AGENDA
Regular Planning Board Meeting
April 27, 2021 - 6:30 PM
TOWN HALL (101 Huntersville-Concord Road)

- 4. Action Agenda**
 - 4.A. R21-01: Huntersville Community Daycare - conditional rezoning request to rezone 10205 Sam Furr Road (Tax ID 00531101) from General Residential (GR) to Highway Commercial Conditional District (HC-CD) to develop a Day Care Center.

Application Summary:

- Petition R21-01 is a conditional rezoning request by Tietort Investments LLLP I to rezone 10205 Sam Furr Road (Tax ID 00531101) from General Residential to Highway Commercial Conditional District. The purpose of the rezoning is to develop a Day Care Center.

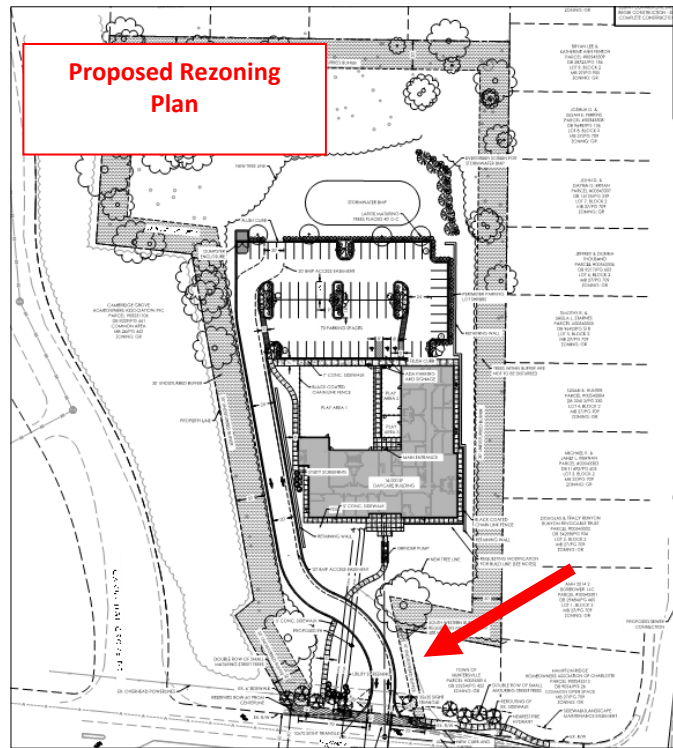
- **UPDATE 4/16/21** – The applicants have amended the plan to remove the western property line buffer modification request. 30 feet undisturbed is now proposed along that property line.

- The remaining modification request is the one adjacent to the Town owned parcel in the front of the parcel (red arrow shown below). The applicants are in the process of contacting NCDOT to see if they will allow the driveway to move further west away from the property and thus establish the required buffer. Staff may be able to support the modification of this buffer if NCDOT requires that it stay at the shown location.

Figure 3

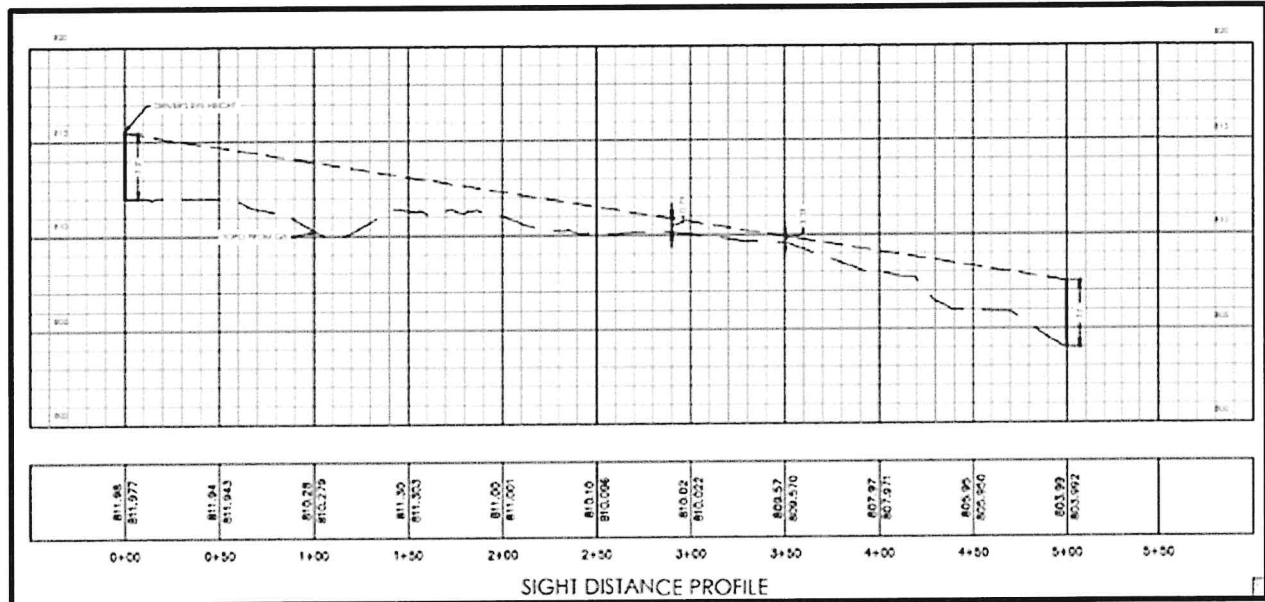
- c) From a review of the Sight Distance Profile (see Figure 3) included in the Rezoning Package, it appears the profile grades were generated by use of GIS data versus an on-site survey using established vertical control. From experience and through consultation with a local Heavy-Highway PLS, GIS surveys lack the accuracy needed to perform a survey of this scope, especially considering the rough GIS topo indicates the sight distance is just a few inches from being non-compliant. It is requested that a vertical survey control be established, and a proper on-site survey be performed by a NC Professional Land Surveyor (PLS) to determine the true Sight Distance Profile.

R08-12 – Approved

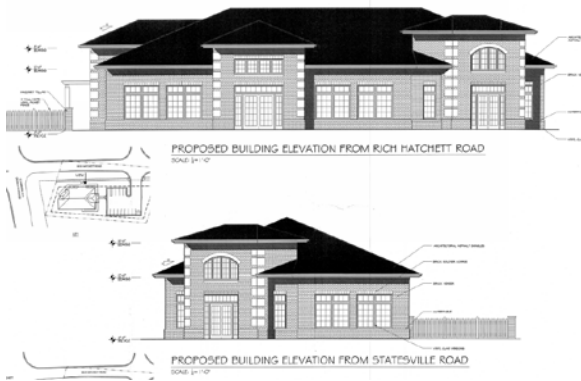
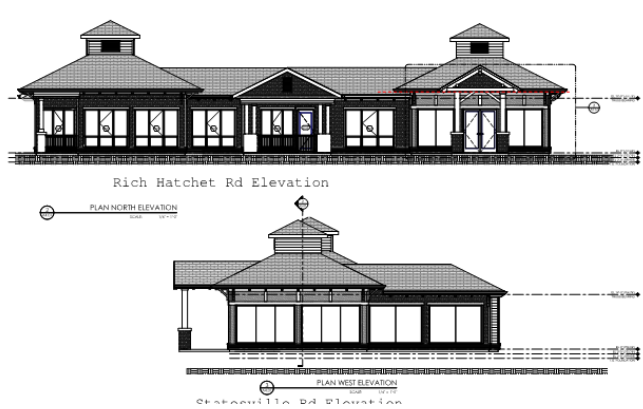
The proposed Conditional District Rezoning Plan will revise the approved building elevations. The site plan will remain generally the same as approved per R08-12. Detailed elevations are included in Attachments B & E
